Maxi Sky 600 - Infrared (IR) System

DATE:	May 5 th , 2008
SUBJECT:	Maxi Sky 600, V4 or V4i equipped with infrared (IR) system
PRODUCT FAMILY:	CEILING LIFTS (FIXED)
DOCUMENT NUMBER:	SAN 04/2008/CA - rev.2
PAGES:	7

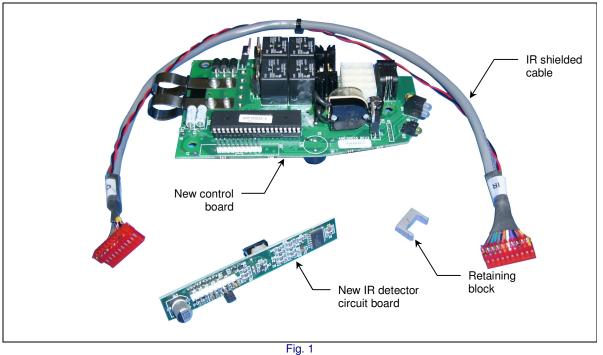
IR detector Part number 492.00038 circuit board

BHM has developed a kit that solves the issues previously mentioned. The components of that kit are depicted in Figure 1. The instructions to make the modification of the IR system are given at the end of this document.

Fig. 3

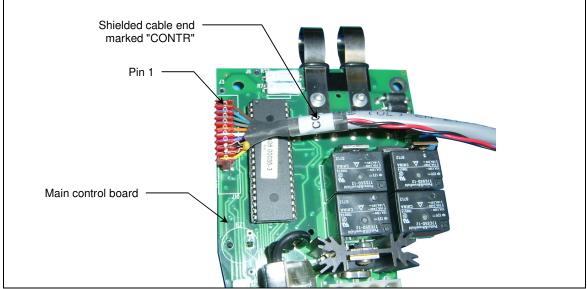
- 2) Remove the old main control board and replace it with the new one supplied in the IR kit.
- 3) Connect the shielded cable end marked "CONTR" to the new control board, as shown in figure 3.

CAUTION: If the shielded cable connectors are not connected with respect to the cable's end labels and to the pin numbers, the unit will fail to function and/or damage can occur to one or both circuit boards.

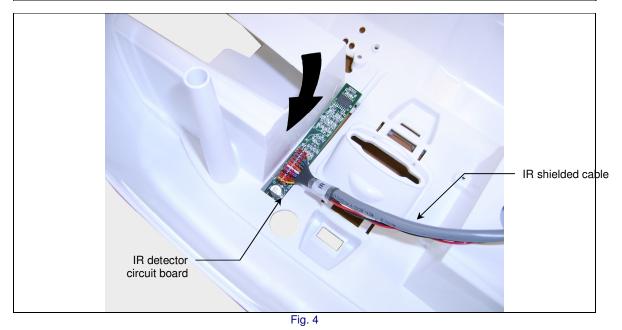
4) Place the IR detector circuit board in its main shell cavity as shown in figure 4.

CAUTION: DO NOT BEND THE CIRCUIT BOARD. Manipulate the IR detector circuit board with extreme care as it is fragile and bending it may cause damage to surface mount components.

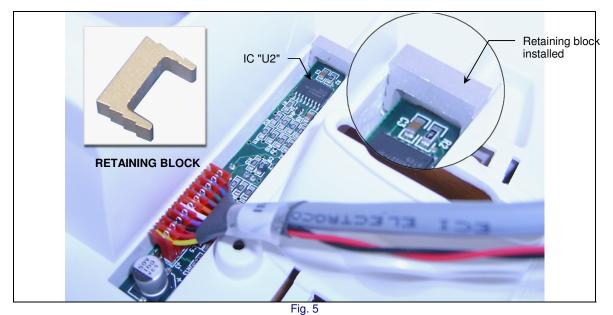
5) Place the retaining block over the end of the IR detector circuit board where IC "U2" is located, as shown in figure 5. Be careful not to allow the retaining block to touch any of the components on the board, since it is made of aluminum, and would cause a short-circuit to occur.
